University Place Proposed Design Standards (July 23, 2021 version)

Review of Incorporation of Previous Comments

Brian Peterson, AIA, Urban Designer T.O.C.H

Figure 1

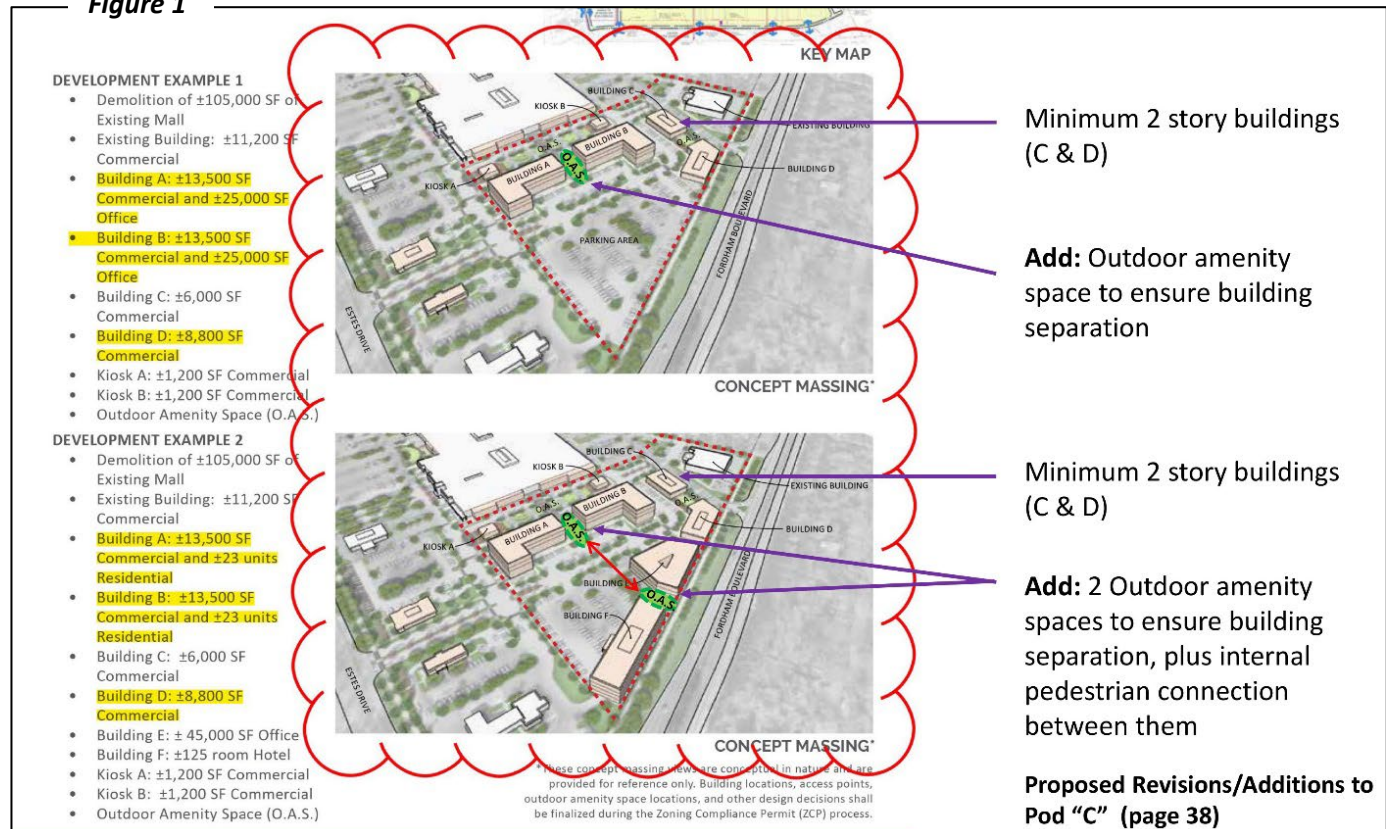
Analysis: The framework plan is still organized according to the “pods” and maximum building lengths/footprints are not addressed. However, it may be possible to limit the size/length of buildings in Pod “C” (the pod with the most development) by ensuring that development occurs as several separate buildings, as is shown in the two development examples, from page 38 (see figures 1 & 2 below). Example One indicates four separate buildings (A-D) and example Two includes six (A-F). It is suggested to ensure building separation between buildings A & B by establishing a defined Outdoor Amenity Space (O.A.S.). If development occurs along the Fordham Boulevard frontage, as shown in Development Example 2, an additional O.A.S. should be provided along the frontage to ensure building separation, and to discourage the possibility of one long building being constructed along the entire frontage. This would also create a view corridor from Fordham through the site to the new main amenity space and plaza. In addition, it is suggested that buildings C & D have a requirement to be at least 2 stories in height, in order to provide a more urban building mass at a key project entrance in contrast to a more suburban one story height.
